ADDENDUM NO. 3

RED CLAY CONSOLIDATED SCHOOL DISTRICT
WILMINGTON CAMPUS RENOVATIONS
BID PACKAGE 'B'

Addendum No. 3 – Consists of the following:

2 PARTIAL POWER PLAN - FIRST FLOOR
1/8" = 1'-0"

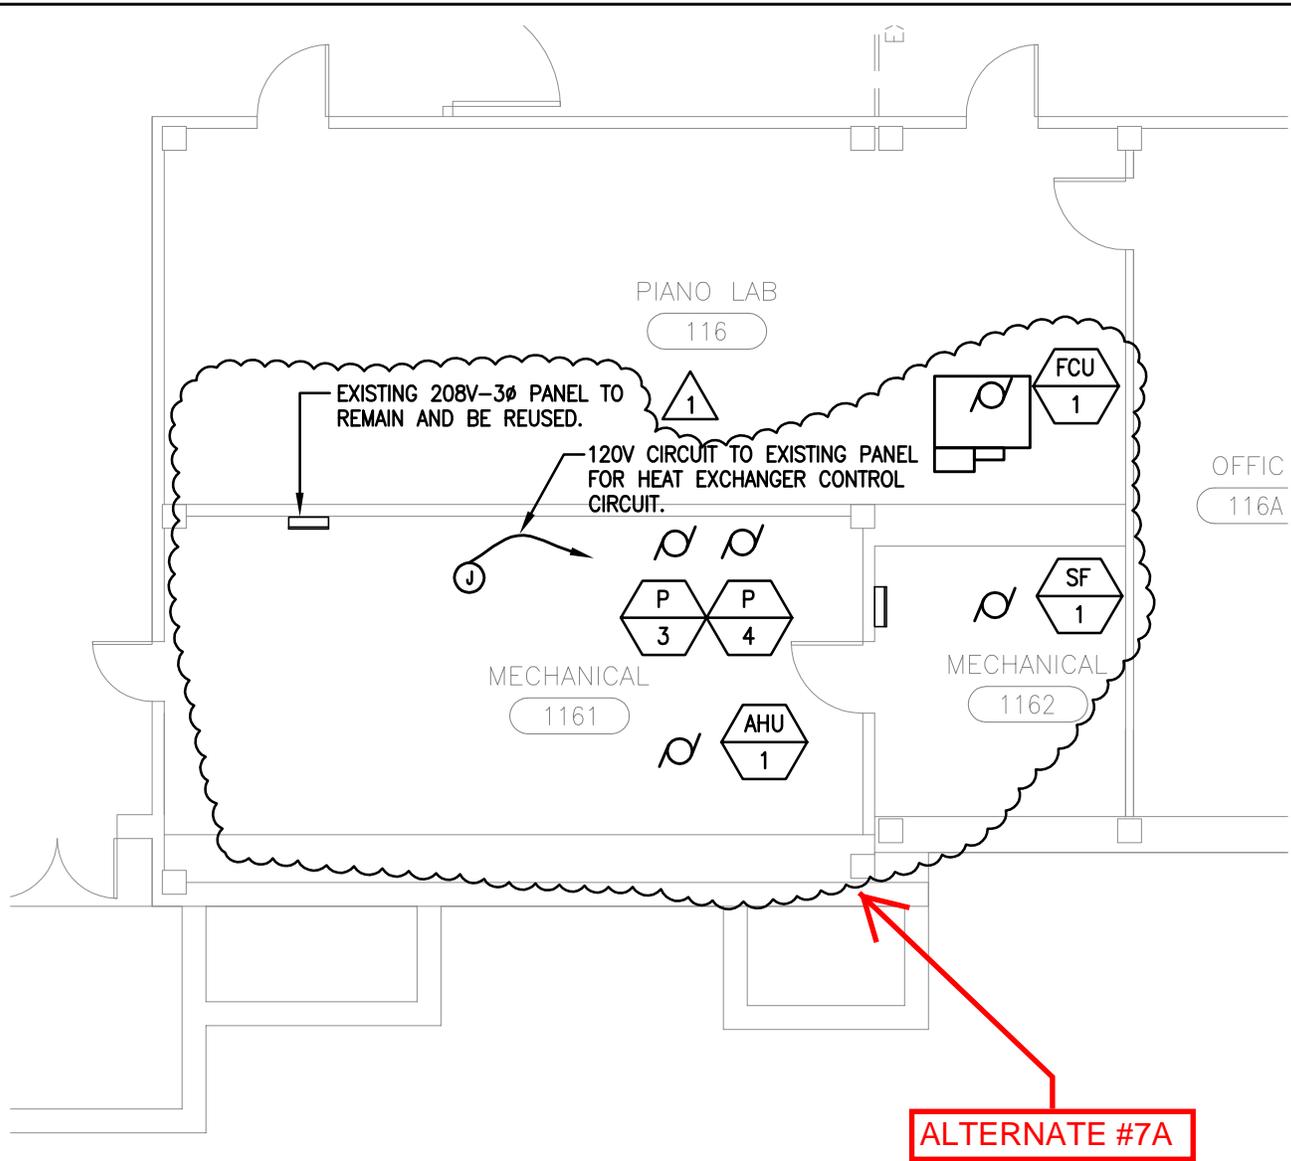
1. Add Plan #2 – Partial Power Plan Third Floor Mechanical room. Refer to attached Sketch E-703.
- AD. E-210 FIRST FLOOR POWER PLAN (ALTERNATE #7A)**
1. Add Plan #2 Partial Power Plan – First Floor Mechanical Room 1161. Refer to attached Sketch E-704.

2 POWER PLAN - SECOND FLOOR
1/8" = 1'-0"

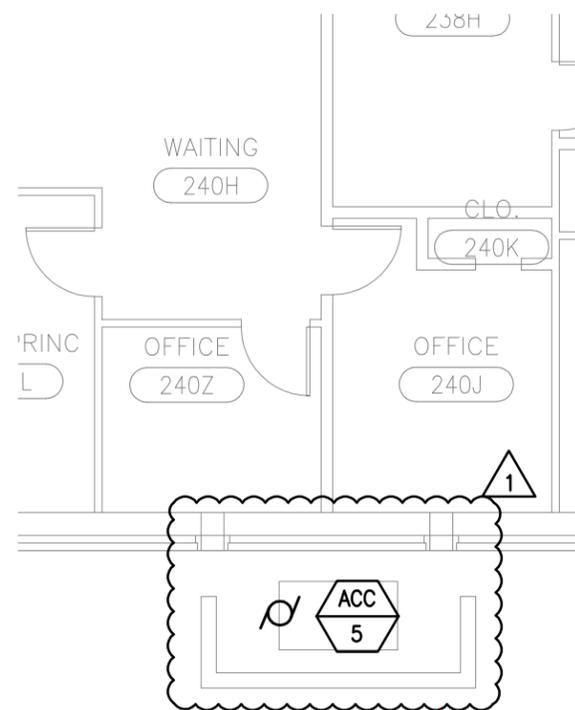
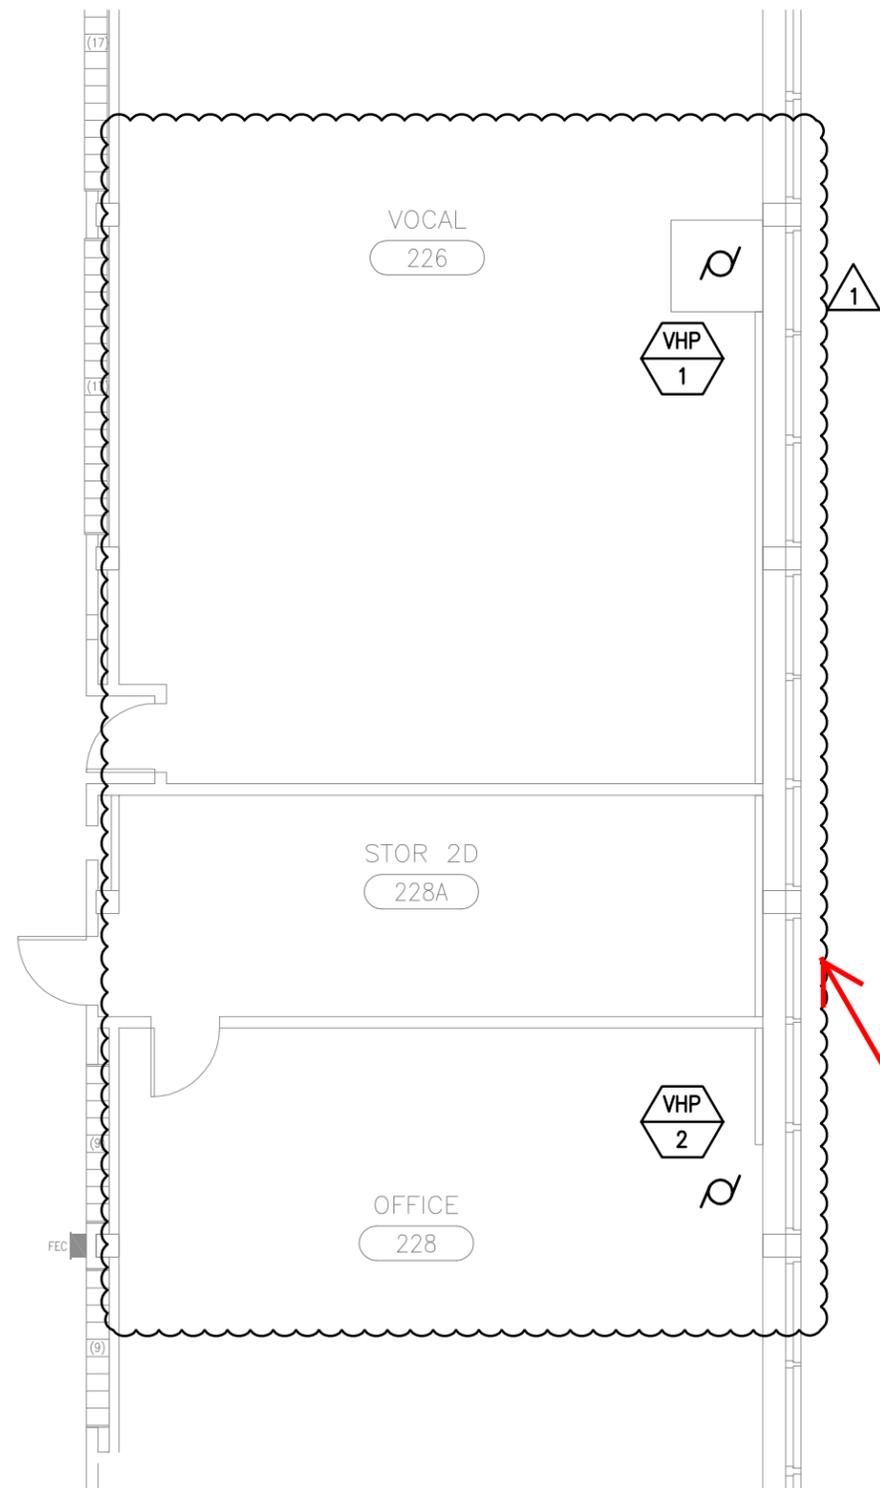
- AE. E-211 SECOND FLOOR POWER PLAN**
1. Add Plans #2 and #4 – Partial Second Floor Administration Area and rooms 226 and 228. Refer to attached Sketch E-705. (ALTERNATES #7A & 7B)
